**CITY OF CARPINTERIA
ARCHITECTURAL REVIEW BOARD
Meeting of December 11, 2014**

**COMMUNITY DEVELOPMENT DEPARTMENT
PROJECT REVIEW**

Project: 14-1738-ARB **Planner:** Nick Bobroff
Address: 5566 Retorno Drive
APN: 003-340-015
Zoning: Single Family Residential (6-R-1)
Applicant: Dylan Chappell Architects for Susan and Bruce Bornhurst

Project Review: Conceptual
 Preliminary
 Final

SITE PLAN

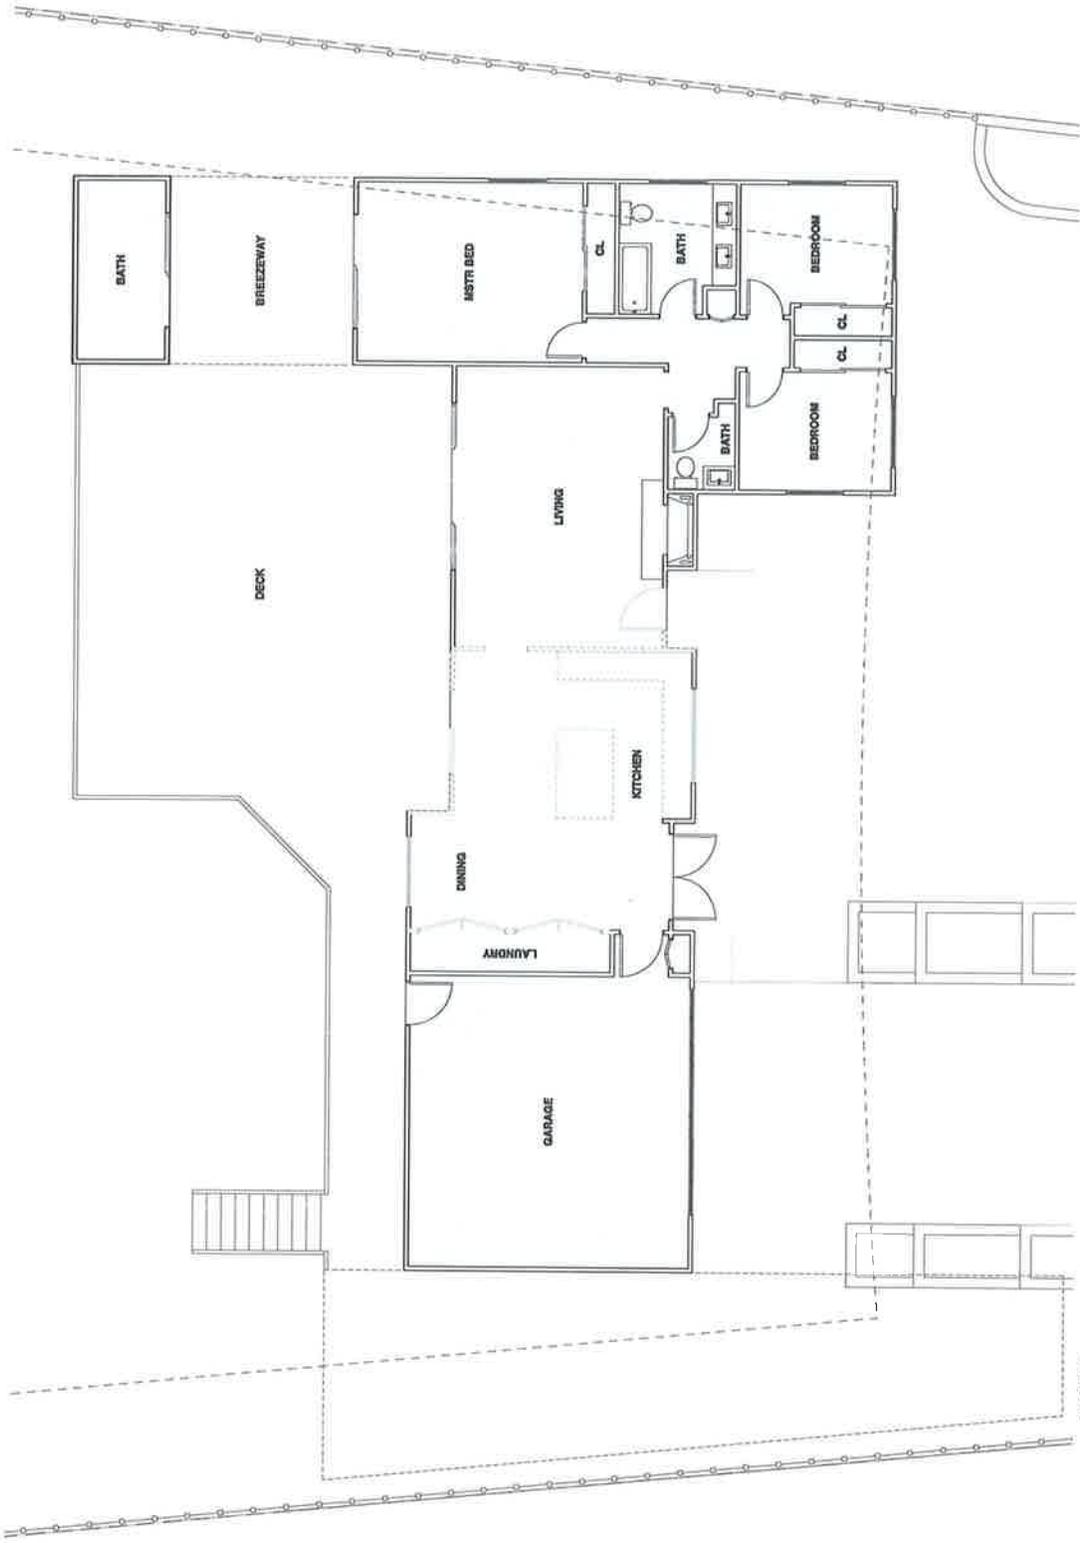
The submitted plans (sheet A1.0) indicate there is an approximately 640 square foot attached patio trellis structure proposed to remain, which is partially located within the required front and (north) side setbacks. A review of City files failed to turn up any permit records for this structure; therefore staff believes this structure is unpermitted. Staff has advised the applicant that if permits do not exist for this structure, then it must be either removed or altered to meet current applicable setback requirements (as described in the above table) as part of this project.

(P) ELEVATIONS
N - E

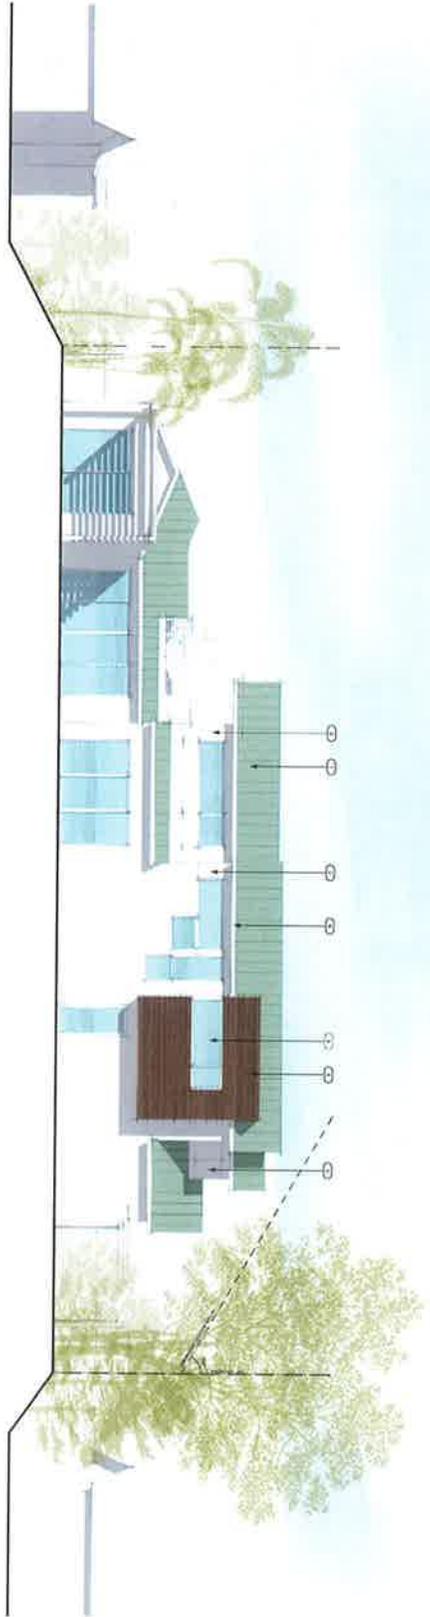
The proposed project introduces a second floor deck along the south side elevation. The second floor is setback from the side property line by 27 feet three inches and is partially screened by the ground floor roof on the existing portion of the home. The plans include a diagram on page A3.2, which indicates the view corridor of the occupants of the subject property and those on the neighboring property, indicating minimal privacy impacts.
